Office Action Summary	Application No. 10/529,249	Applicant(s) RAZAVI, ABBAS	
	Examiner RIP A. LEE	Art Unit 1796

DETAILED ACTION

This office action follows a response filed on June 23, 2008. Claims 21 and 39 were amended. Claims 21, 23-27, and 32-41 are pending.

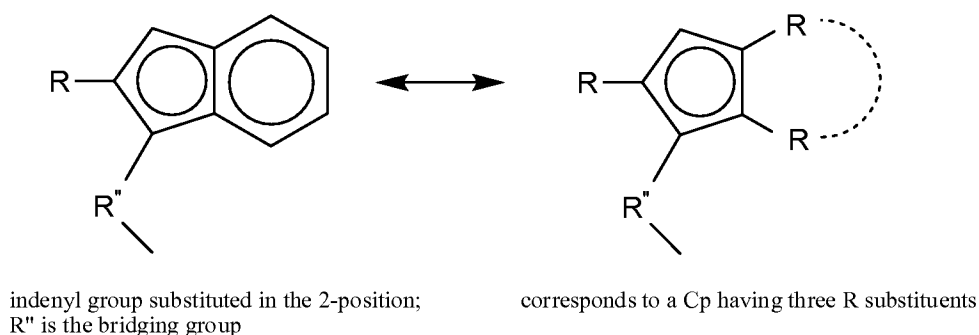
Instant claims have been amended to limit the number of substituents R on the Cp ring as integer $n = 1, 2$, or 4. Since claims attempt to describe a particular substitution pattern, the definition of n must be precise. The current definition is fatally defective because R has been defined as hydrogen or a hydrocarbyl radical containing from 1 to 20 carbon atoms, or two carbon atoms (apparently from R) are joined to form a C₄-C₆ ring. Thus, it is not clear whether n defines the number of hydrogens, the number of hydrocarbyl radicals, or the number of both hydrogen and hydrocarbyl radicals.

The current definition is also not internally consistent. Since metallocene (II) contains a bridging group, four ring positions are available for substituent R. Thus, integer n is *necessarily* equal to four for *all* substituents R.

The Cp ring of a metallocene is conventionally expressed as (C₅R _{n} H_{5- n}) where there is delineation of hydrogen and hydrocarbyl substituents, R, on the five membered ring, C₅. For metallocenes containing bridged Cp rings, the Cp ring would be defined as R''(C₅R _{n} H_{4- n}), where R'' represents the bridging group. This represents a more precise description of Applicant's metallocene (II). If the Cp ring contains only one hydrocarbyl group R, then the Cp ring must contain three hydrogen atoms. Also, if the Cp ring contains only one hydrogen, then the Cp ring must contain three hydrocarbyl groups. Note however, that integer n can not equal three. Thus, the definition provided by Applicant is not internally consistent.

Based on these considerations, the claims as amended are rendered indefinite for failing to particularly point out and distinctly claim the subject matter which Applicant regards as the invention.
